More on the proposed desecration of Glen Etive

The Allt Mheuran scheme

The revised Allt Fhaolain proposals

Fig. 2 Temporary access track to intakes during construction to be reinstated to allow ATV access afterwards on Bhorain, Gaoirean, Charnan, Fhaolain and Ceitlein.

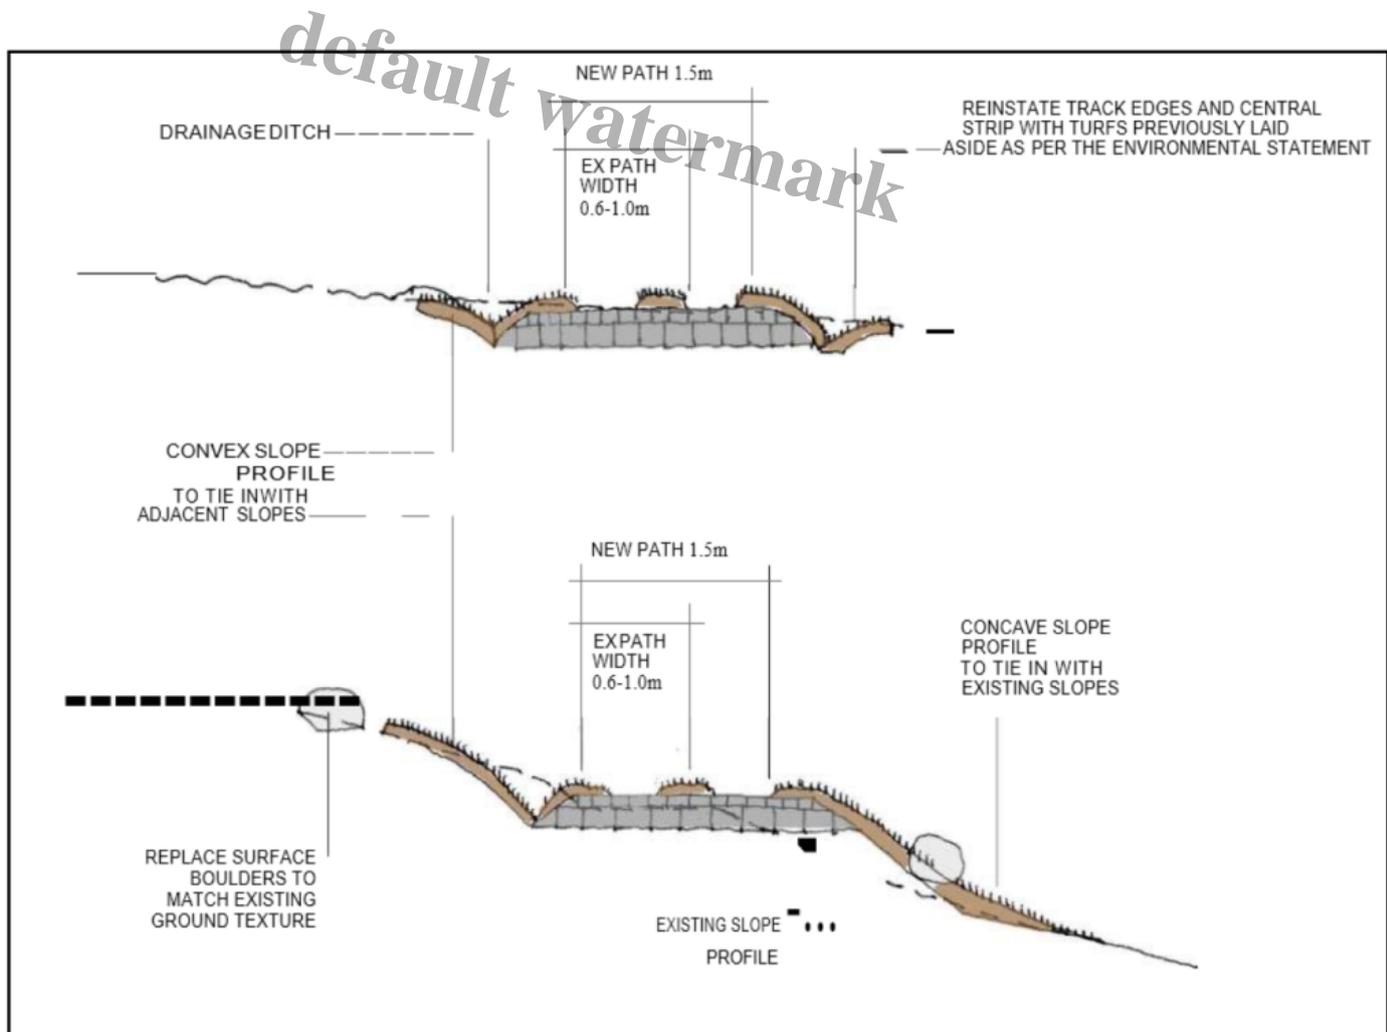
The text below the diagram appears to clarify that the proposal to narrow construction tracks to ATV width applies to five out of the seven schemes. While the Allt Mheurán tracks are now to be removed completely (see below) it's not clear what is being proposed for the Allt Chaorunn where some new track was to be removed and some retained.

The diagram illustrates that Dickins Hydro is not actually proposing to restore the tracks which would mean removing the imported material but rather to cover them up. That will have a lasting impact on landscape and ecology. What is not explained.

Standard advice on track design recommends that if they are to avoid significant landscape impact they need to avoid cutting across slopes as illustrated.

So what exactly is being proposed for the five schemes listed under the diagram? We don't know. Statements such as this do not inspire confidence:

Revised location plan. It appears only the track above the powerhouse will be removed, leaving a new and 'upgraded' tracks along the bottom of the glen.

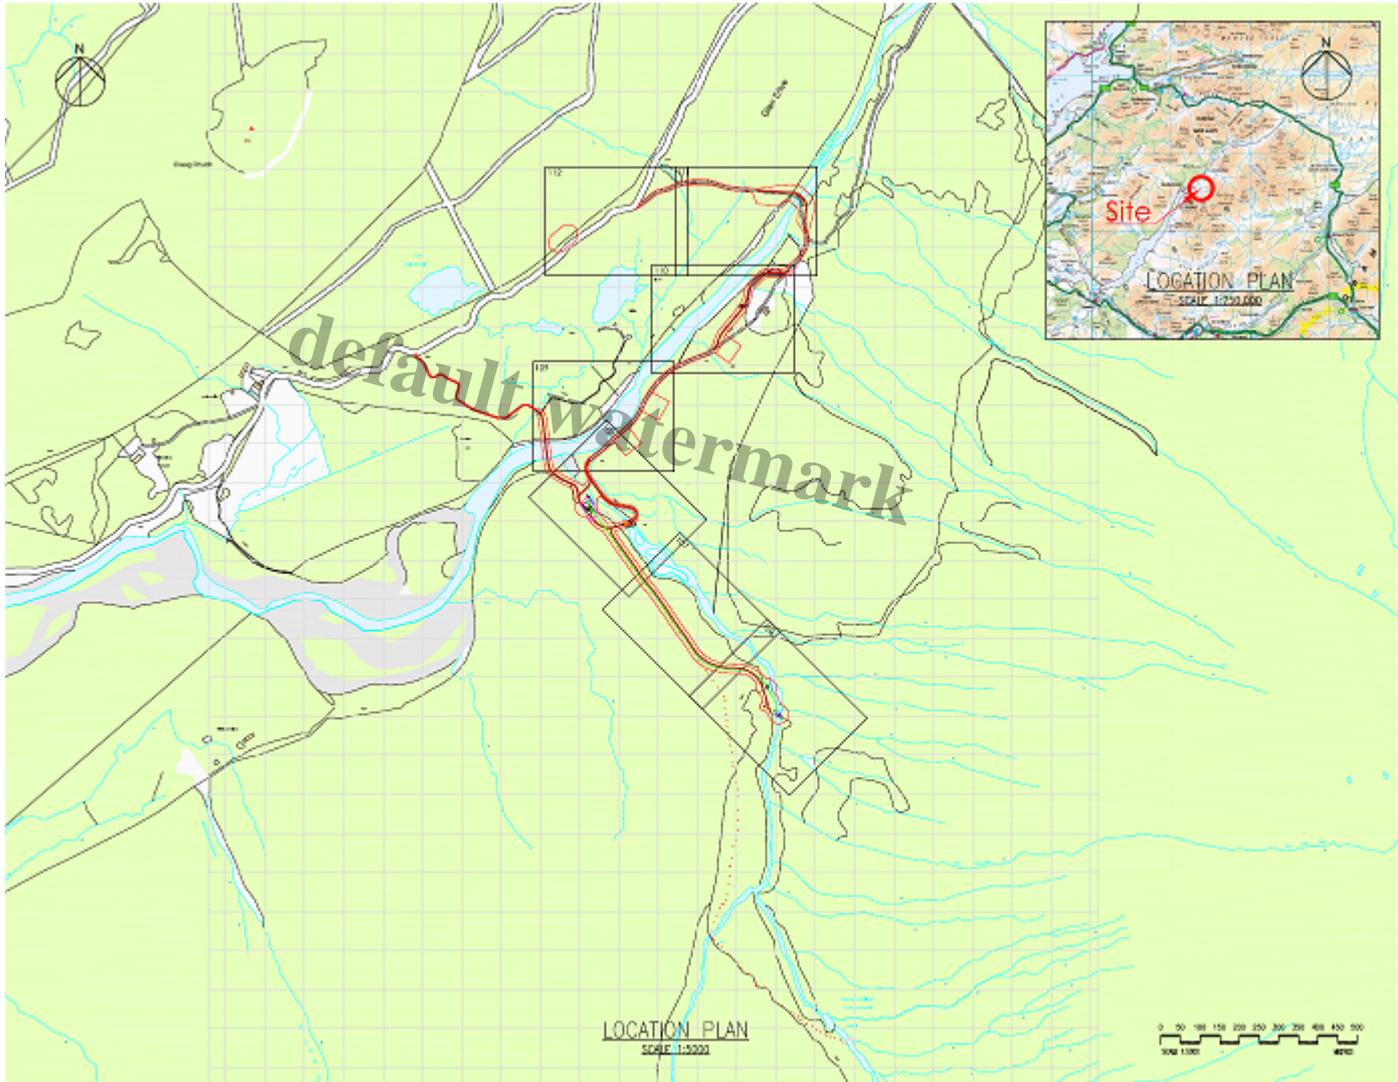
Unfortunately the claims don't match reality. The revised proposals ([see here](#)) are still far from clear, show that new tracks are still being proposed and raise a number of other serious landscape issues:

- 'regular maintenance inspections of the intake will be done on foot with cleaning equipment kept on site, to minimise long term impact. On occasion should materials and equipment be required on site, these could be ferried there by quadbike, thus minimising the impact.' So will access be on foot, by the existing path, or quad bike? Regular quad bike use will have a deleterious landscape impact. It therefore needs to be controlled.
- **2.2.4 New access around Coileitir**
A new permanent access track to the Mheuran powerhouse, around the south side of Coileitir, is proposed. SEPA request a habitat survey for the new access track, however DHR Ltd submitted this report and habitat map with the original planning application. So not all new construction

tracks are going to be restored after all? What is the specification for this new track? The Developer says this will be upgraded and realigned but gives no apparent consideration to the landscape impact.

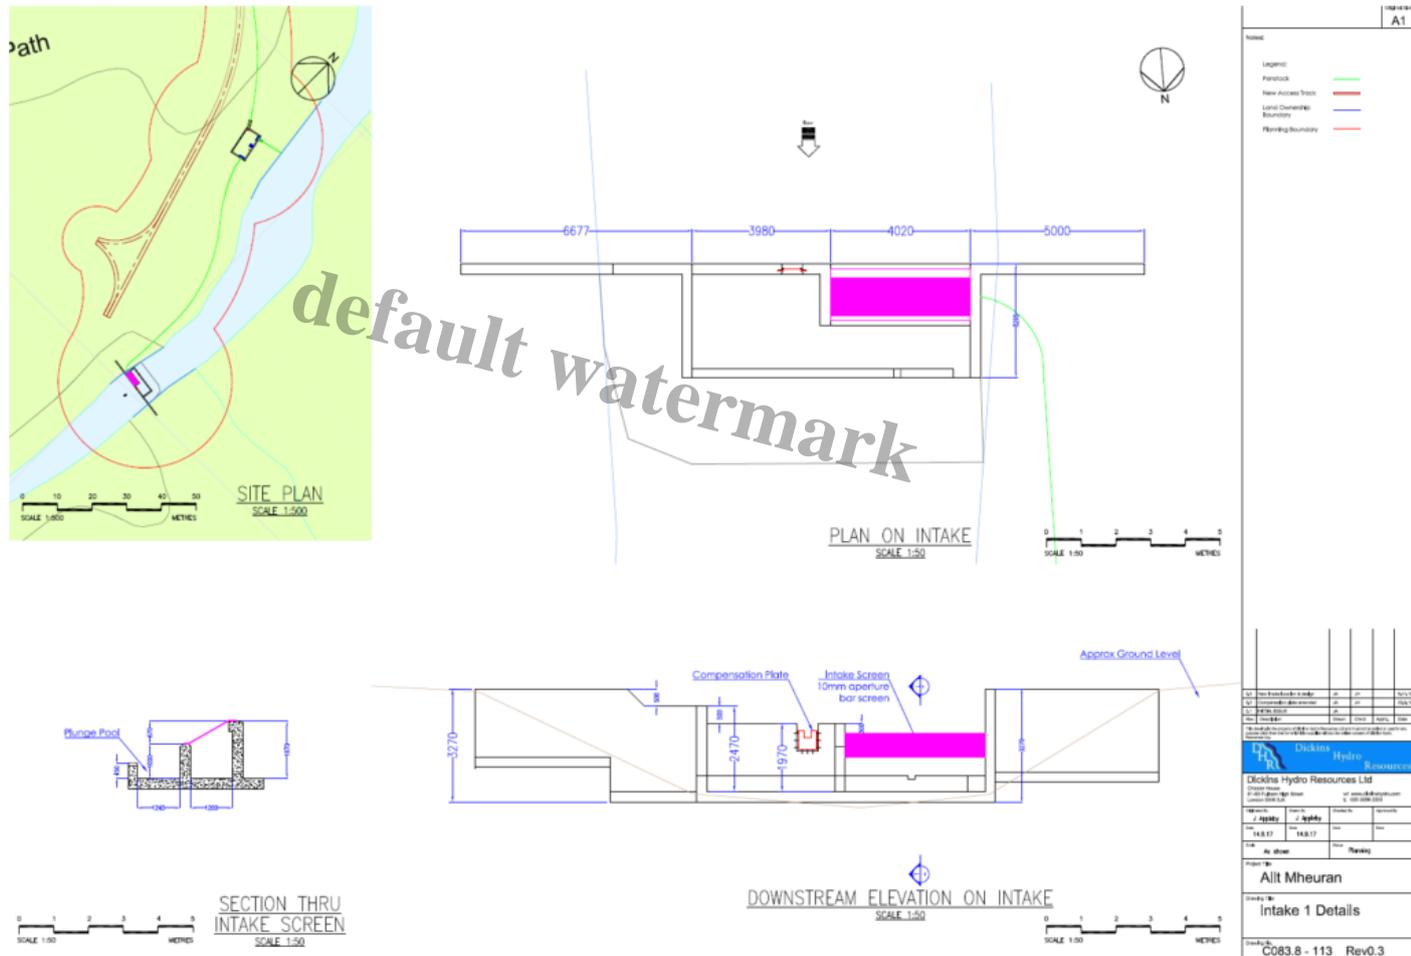
- There is second section of new, and presumably permanent, access track which heads more directly across the River Etive (see plan above). Again, I cannot find any assessment of the landscape impact.
- The Zone of Theoretical Visibility Assessment has not been revised â?? it dates from December 2017 â?? despite the significant changes to the scheme

The Intake 1 details are still dated 2017.

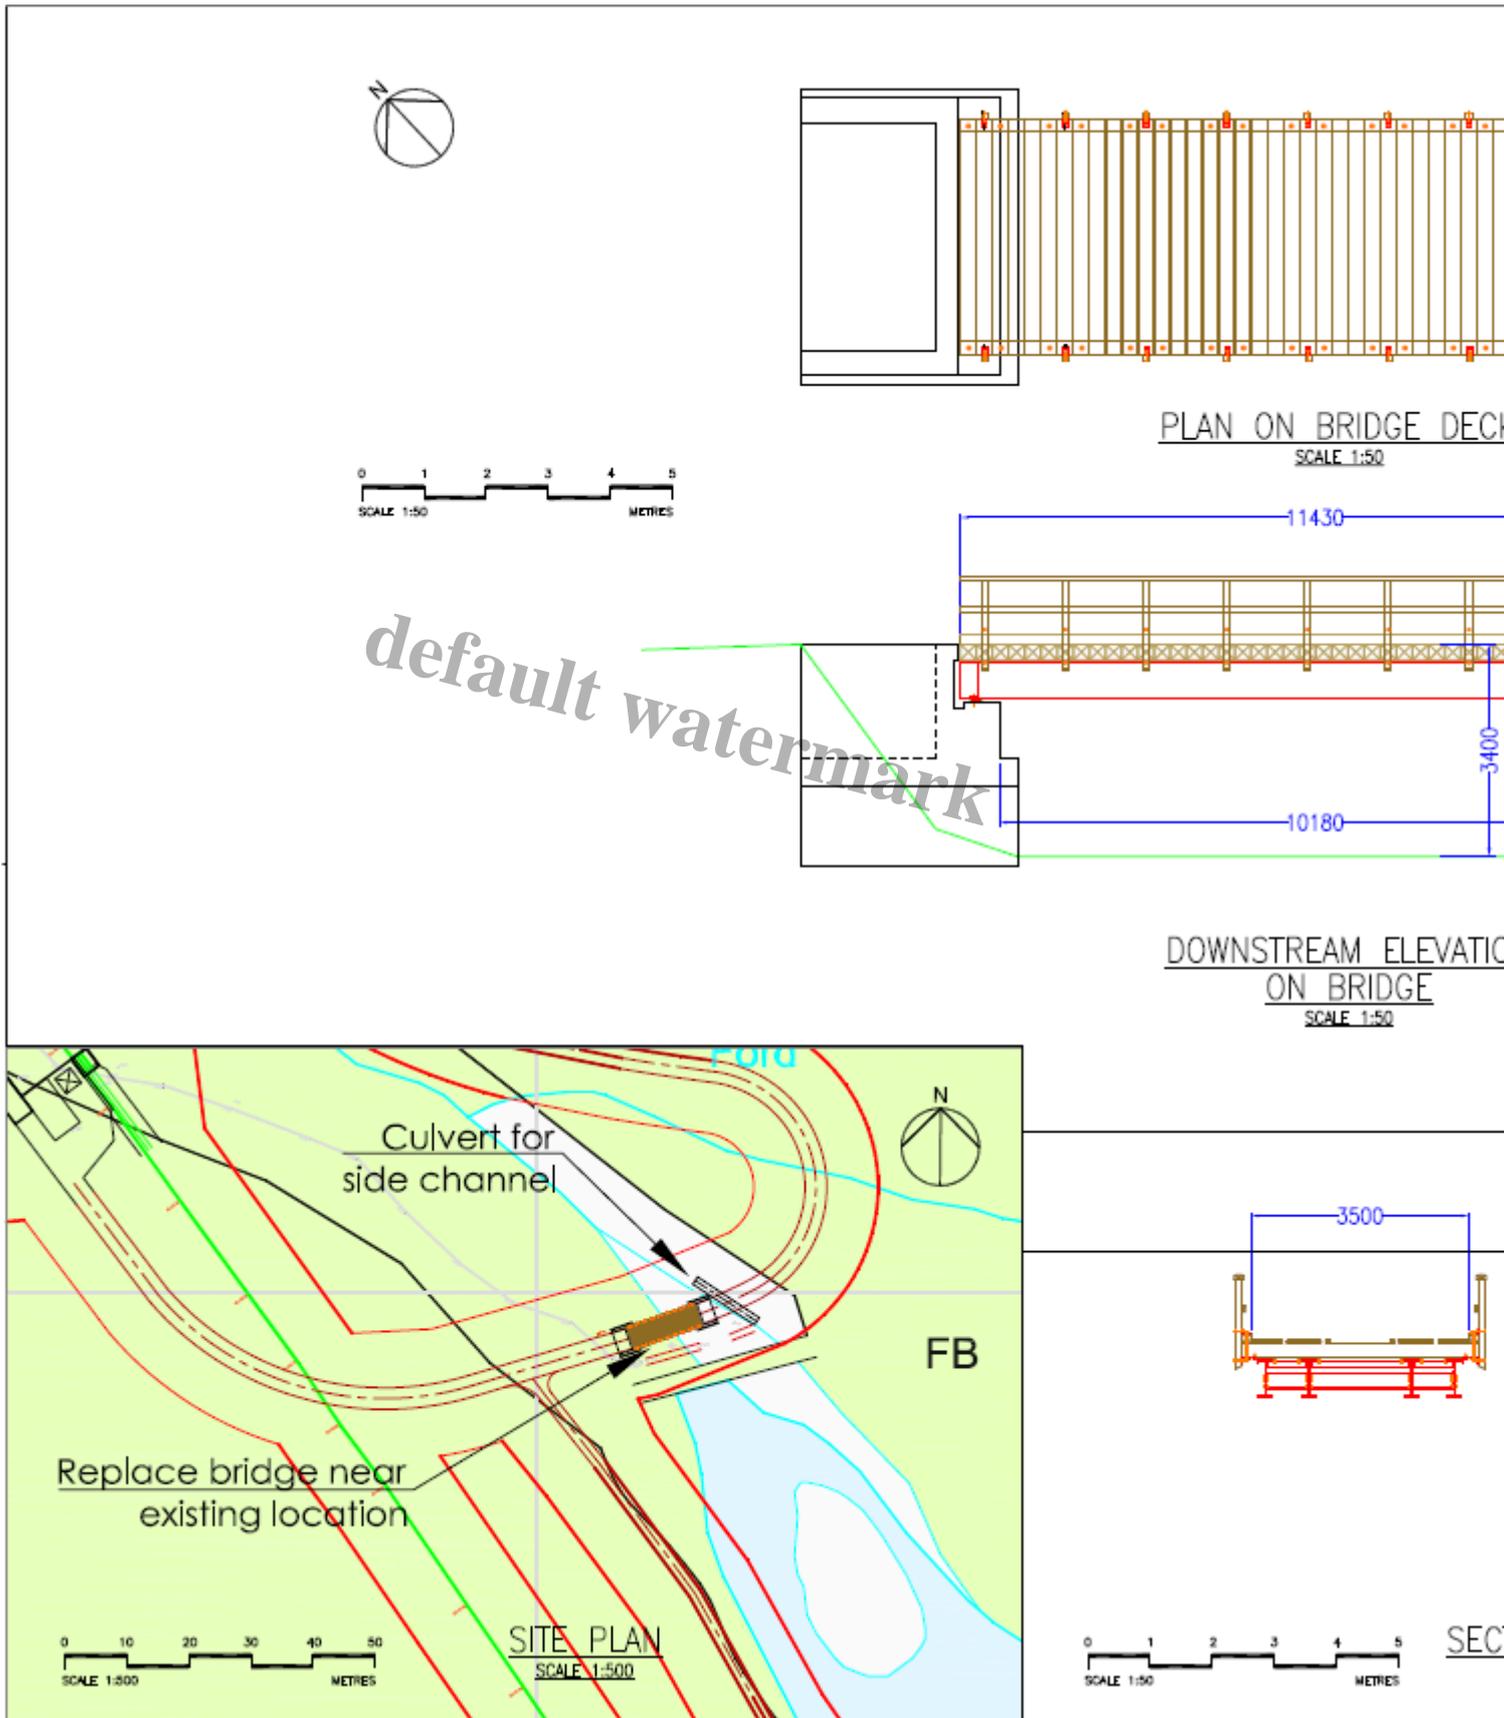
- While a new map has been added to the intake document dating from last year showing its location (along with what appears to be a permanent access track!) its unclear how the proposed design will fit in the proposed location, let alone how it will look. The size of any pool, the use of rip rap bouldering and whether the concrete walls will be faced in stone appear not to be considered.

North east Elevation

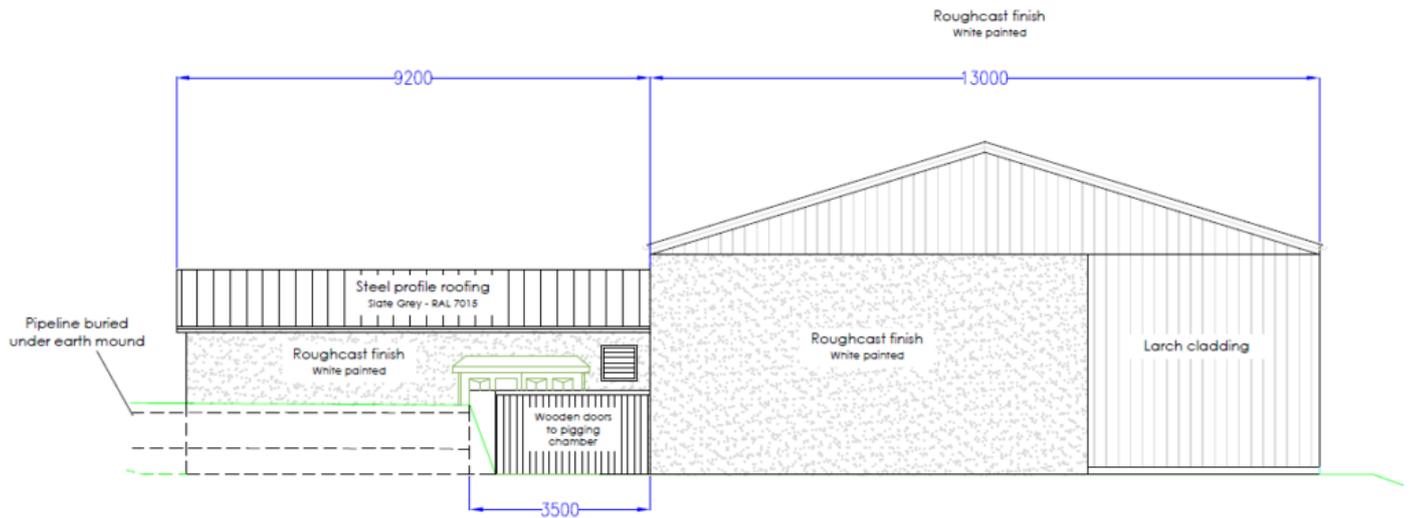
- Design details for the new bridge are also not supplied. The supporting pillars appear to be in concrete, totally out of keeping for Glen Etive

- The Powerhouse is in an open location, large and with a steel roof. Much of the walls will finished in white roughcast rather than natural materials. How is this appropriate for a National Scenic Area?

The previous Zones of Theoretical Visibility dating from Dec 2017 has been resubmitted
â?? perhaps this is just a mistake?

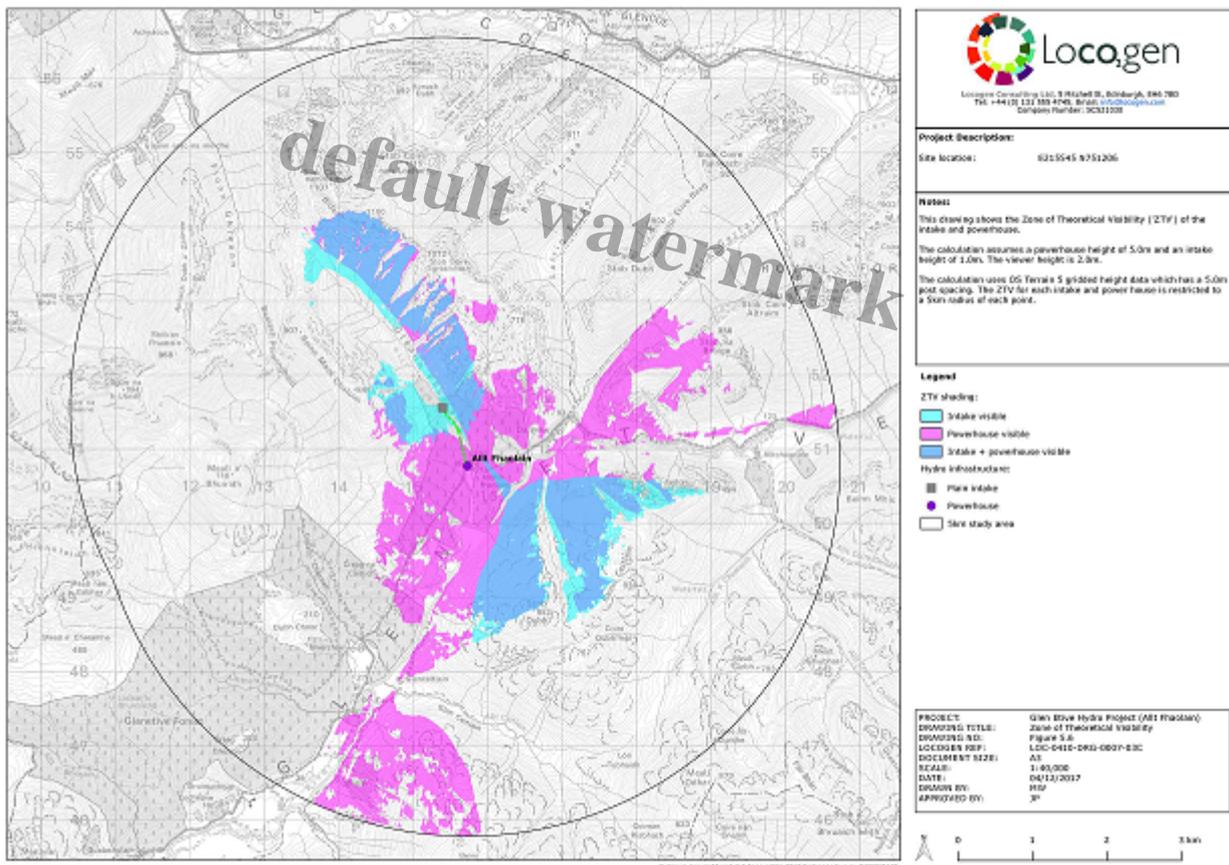
While the supporting documentation claims the Landscape Impact Assessment has been revised, the Assessment of Zones of Theoretical Visibility (Doc 5.6) still dates from December 2017 and still shows the powerhouse south of the road. While the powerhouse should now be less visible the assessment failed to include any consideration of the impact of the 'upgraded' and new sections of access track on the landscape.

Ancient woodland is marked with brown hatching

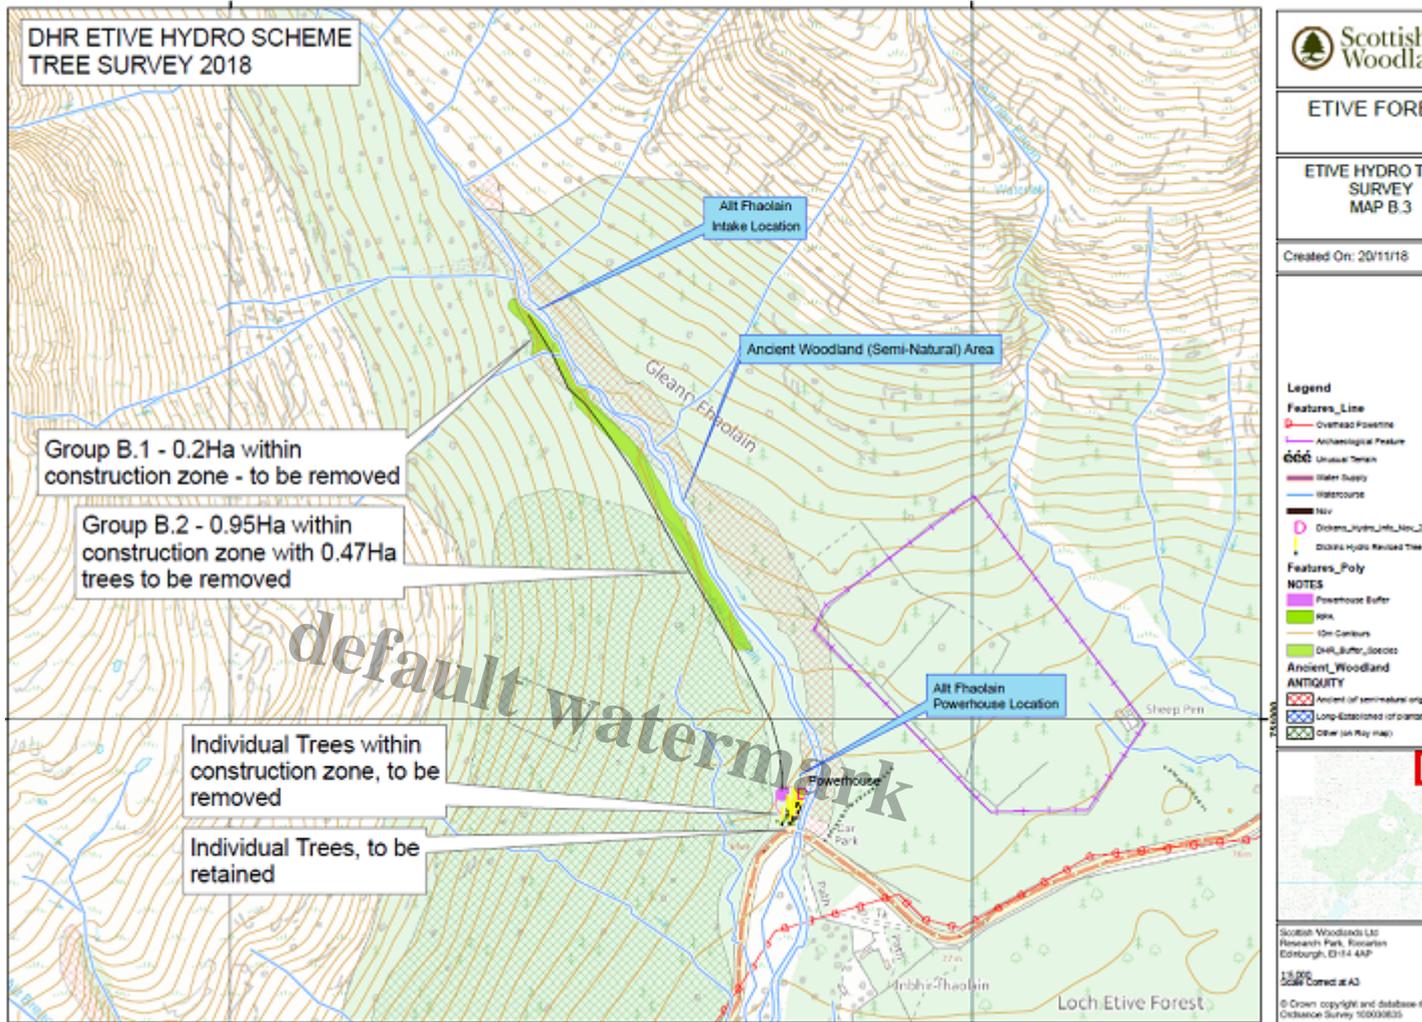
Ancient woodland runs along the Allt Fhaolain and the scheme will destroy some of this in its upper reaches, like the other schemes on the west side of the River Etive. There is still no proper assessment of the impact of these schemes on native woodland or on the scenery as the forest plantations are felled.
